EEG-55

**IMPLICATIONS OF THE PRESENCE OF
PETROLEUM RESOURCES ON THE
INTEGRITY OF THE WIPP**

Environmental Evaluation Group
New Mexico

June 1994

Figure 4. Producing oil and gas wells in the abandoned ORNL Study Area which was characterized by Netherland et al. (1974) as not having economically recoverable oil and gas reserves.

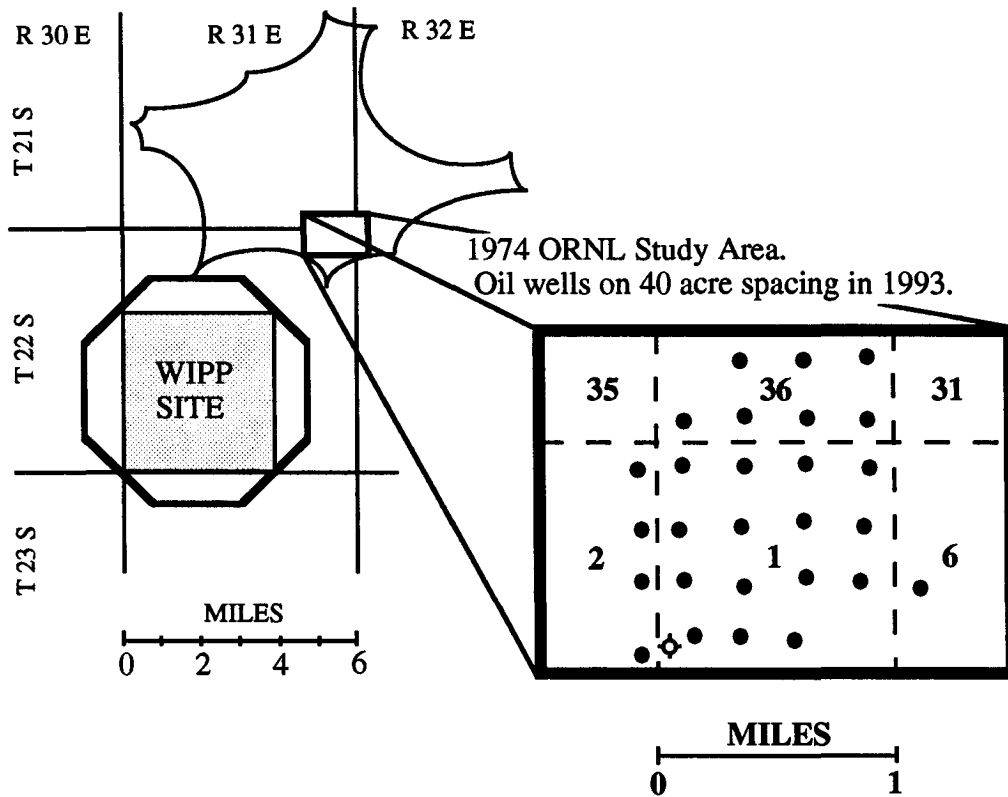
That repository site (ORNL Study Area, Figure 3) was abandoned and the site was reopened for oil and gas exploration. Figure 4 shows oil wells on forty acre spacing throughout much of the original WIPP Site (ORNL Study Area). The firm conclusion of Netherland et al. (1974) was wrong.

Figure 6. Production Trends. (Griswold, 1977)

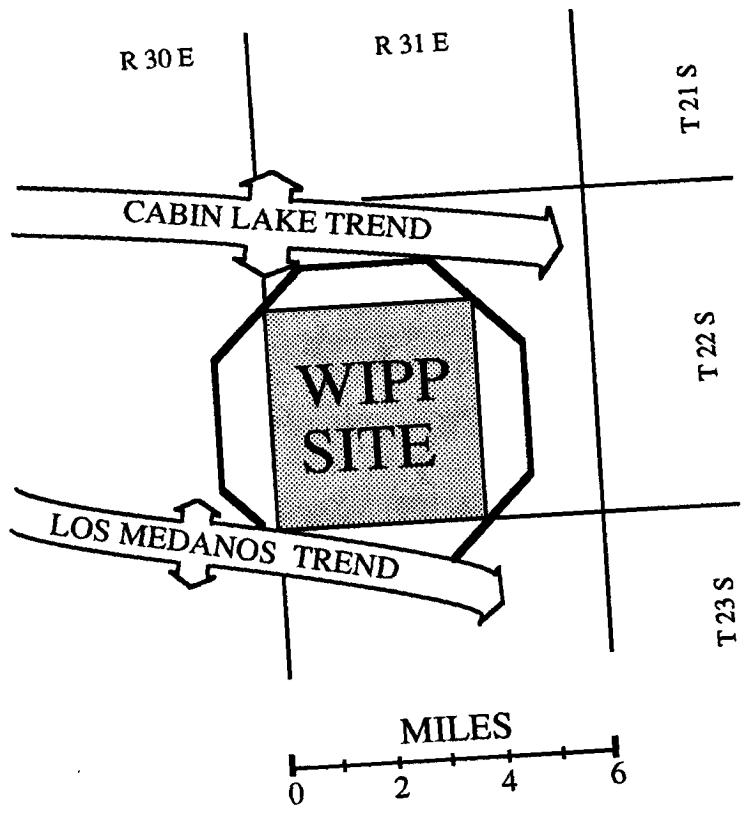
Two of the production trends cited by the Geologic Characterization Report (GCR) are shown in Figure 6. The GCR argues that known oil and gas trends "minimize the possibility of siting over areas having favorable potential for discovery of additional hydrocarbon reserves." However, in a largely unexplored

area, production trends alone do not establish petroleum reservoir boundaries. As noted by Foster in describing the Pennsylvanian Formation, the geographical limits of petroleum production in the vicinity of the WIPP had not yet been identified.

Figure 7. Oil and gas leases within the WIPP Site according to the DOE FEIS (U.S. DOE, 1980, Figure 8-6, reproduced with permission).

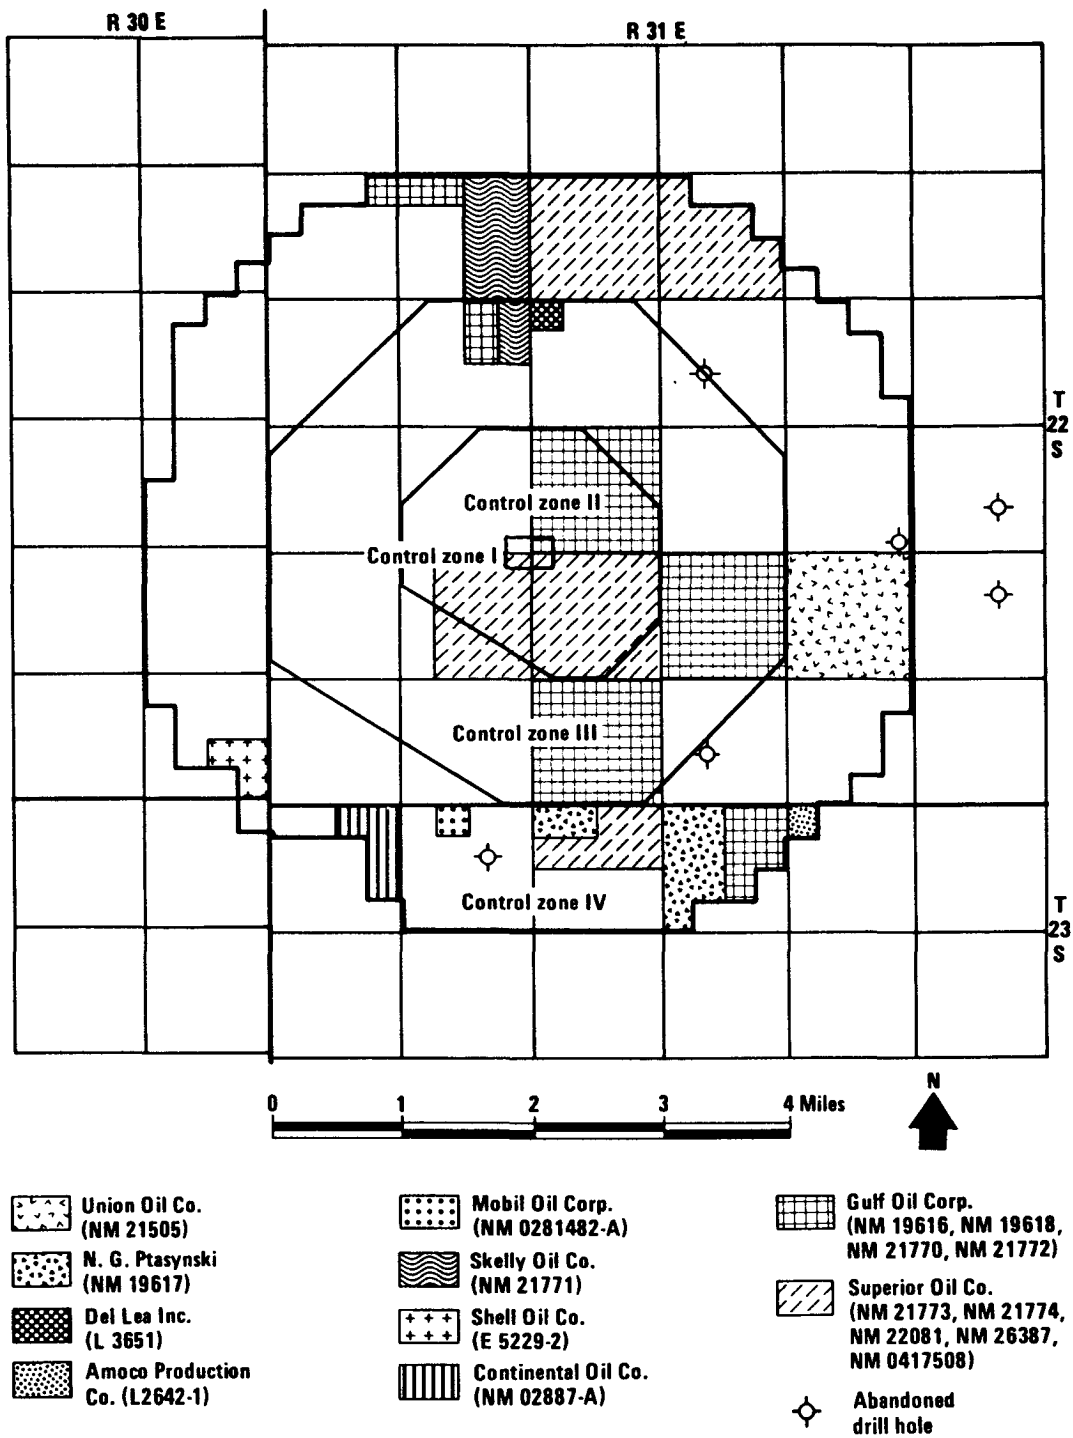
It is also unclear why the map published in the WIPP FEIS (U.S. DOE, 1980, Figure 8.6) and shown in Figure 7 disclosed six abandoned drill holes, including two abandoned drill holes outside Control Zone IV, but failed to show four other abandoned drill holes and the eight producing oil and gas wells identified by Griswold (1977).

Figure 10. Mean drilling intensities inferred from elicitation of expert judgment. Plot includes full credit for 100 years of active institutional control.

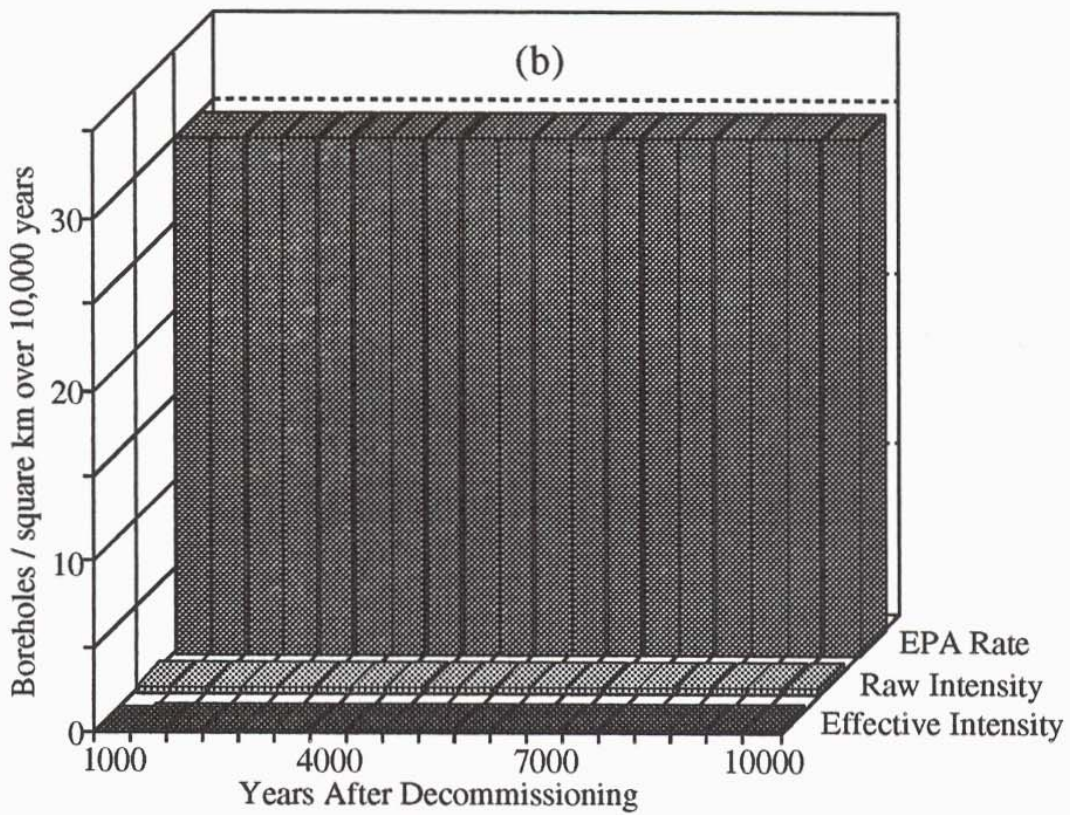
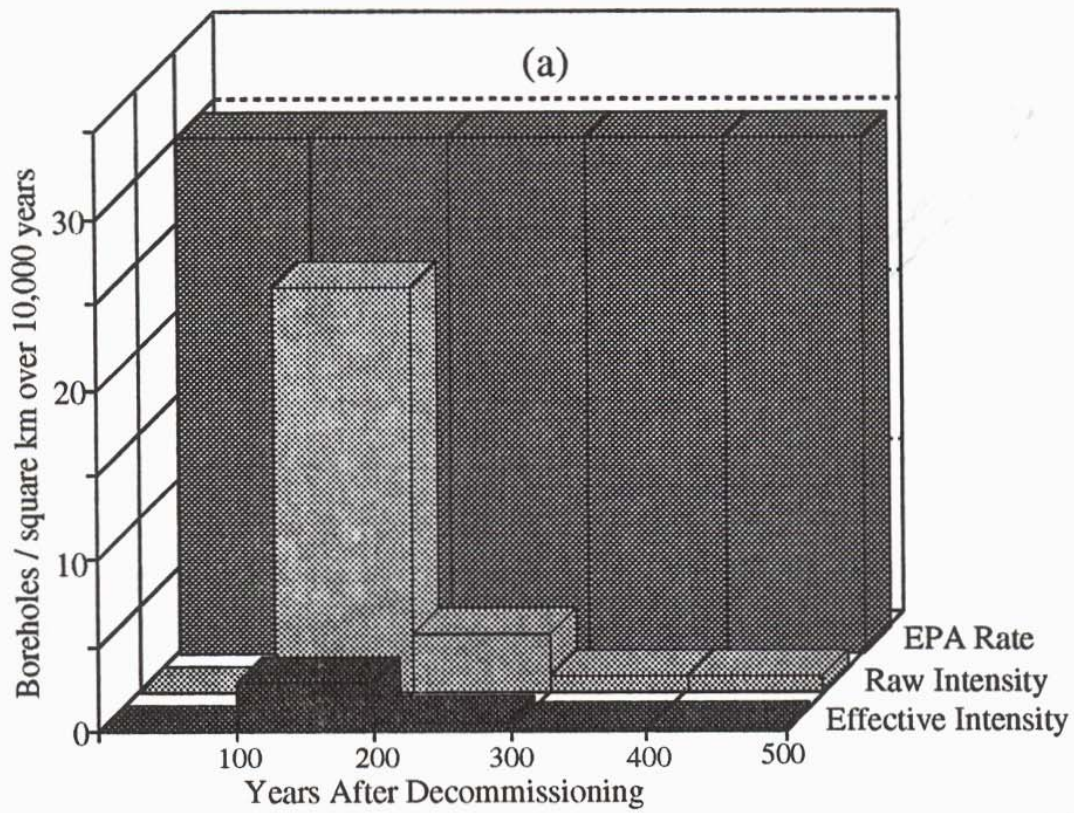
Figure 10 (a and b) compares the drilling rates suggested by EPA (1985, 1993) and those proposed by Hora (1992). The EPA Standards (U.S. EPA, 1985) for the disposal of transuranic waste specify a maximum drilling rate of 30 boreholes per square kilometer over 10,000 years (U.S. EPA, 1985, p. 38089). The raw drilling intensities shown in Figures 10 (a and b) reflect drilling rates inferred from elicitation of the "futures" panel. The effective drilling intensity reflects drilling rates inferred from elicitation of the "markers" panel. The drilling rates estimated by Hora are consistently and substantially lower than the EPA maximum for sedimentary geologic formations. Hora (1992, p. 88) reported the *largest* time integrated drilling intensity from among 1,000 vectors for the entire regulatory period to be only 1.11 boreholes per km² over 10,000 years. For the 1,000 to 10,000 year period after closure, or 90% of the regulatory period, Hora (1992) estimated the raw drilling intensity as 0.3 boreholes per square kilometer over 10,000 years or 2 orders of magnitude less than the EPA maximum of 30 boreholes per square kilometer over 10,000 years.

Figure 11. Oil and gas exploration and production in the immediate vicinity of the WIPP until 1977.

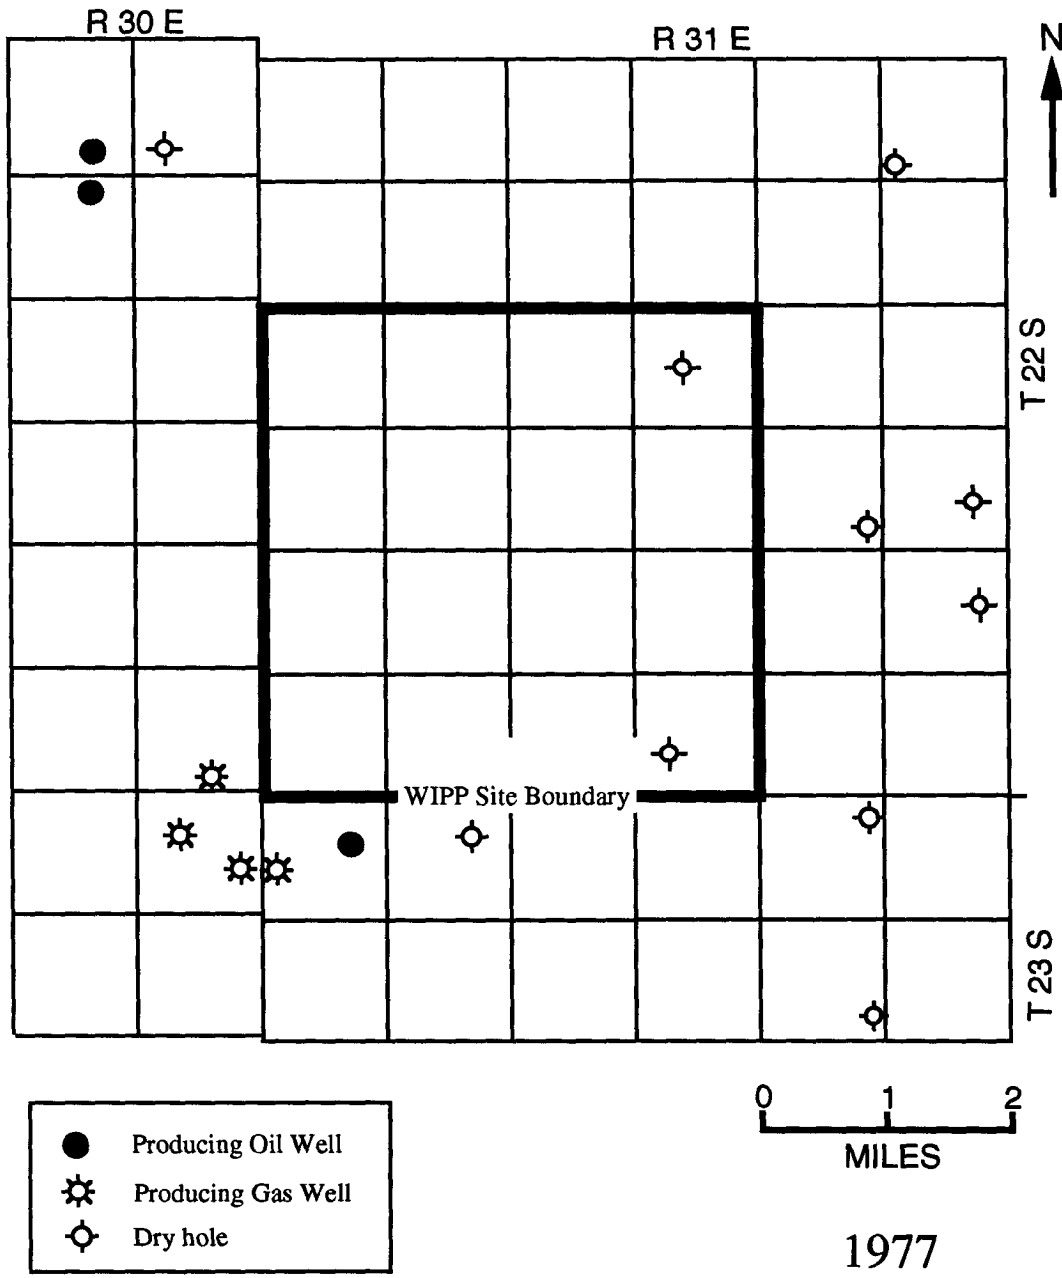
Figure 11 shows the number of oil and gas wells in the immediate vicinity of WIPP in 1977. The map includes a two mile (3.2 km) border encompassing the 124 km² area surrounding the WIPP Site Boundary. Until 1977, 15 oil and gas wells (including dry holes) had been drilled within this 3.2 km border region. If the EPA maximum drilling rate of 30 boreholes per km² per 10,000 years had been sustained following 1977, an additional 8 wells would have been drilled by 1993. However, Figure 12 shows an additional 99 oil and gas wells¹⁸ drilled from 1978-1993 in the region. If averaged over 15 years, that yields a drilling rate of 530 boreholes per km² per 10,000 years. Table 3 lists the drilling rates extrapolated from yearly data for the area immediately surrounding WIPP. In 1991, the drilling rate peaked at 3057 well bores per km² per 10,000 years.

Figure 14. March 1993 applications to directionally drill eight oil wells to be completed within WIPP Site Boundary.

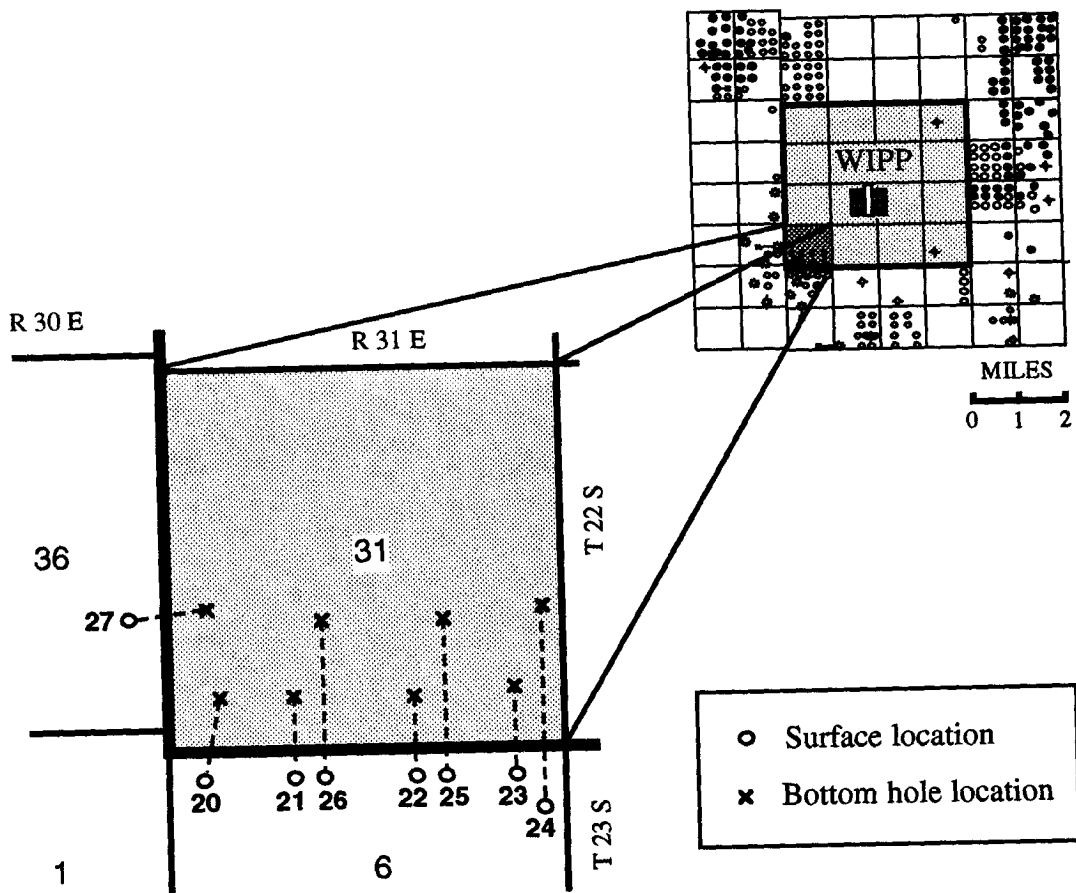
In March 1993, Bass Enterprises submitted applications to directionally drill eight additional wells beneath the WIPP Land Withdrawal Area for the production of crude oil from the 320 acre lease (NM 02953C) in the southern half of Section 31, T22S, R31E. The surface locations are shown in Figure 14 as open circles

and the bottom hole locations are shown as x's. Drilling would initiate on the surface outside the WIPP Site Boundary, proceed downward at least 6000 feet, then deviate into the WIPP Site Boundary. On April 26, 1993, the BLM (Manus, 1993) sent the applications to the DOE for review stating that BLM would withhold approval on these APDs until comments were received from the DOE. Under 43 CFR 3162, the BLM has a 30 day period for the processing of APDs and following that period, BLM makes a decision to permit, deny, or postpone the applications. On May 27, 1993, the DOE WIPP Project Site Office (Hunt, 1993a) notified the BLM that the applications would require the review of the DOE Headquarters and the Administrator of the EPA. The DOE suggested that BLM apply subsection 3162.3-1(h)(3) of 43 CFR 3162 to allow DOE and EPA additional time to review the applications. On July 26, 1993, the DOE (Hunt, 1993b) requested an additional extension or deferral to allow completion of EPA's decision making process. On October 28, 1993, the EPA suggested that the DOE and the EPA could jointly ask the BLM to delay judgment on the applications to drill (Shapiro, 1993). As of April 1994, the status of these applications appears to remain unresolved.
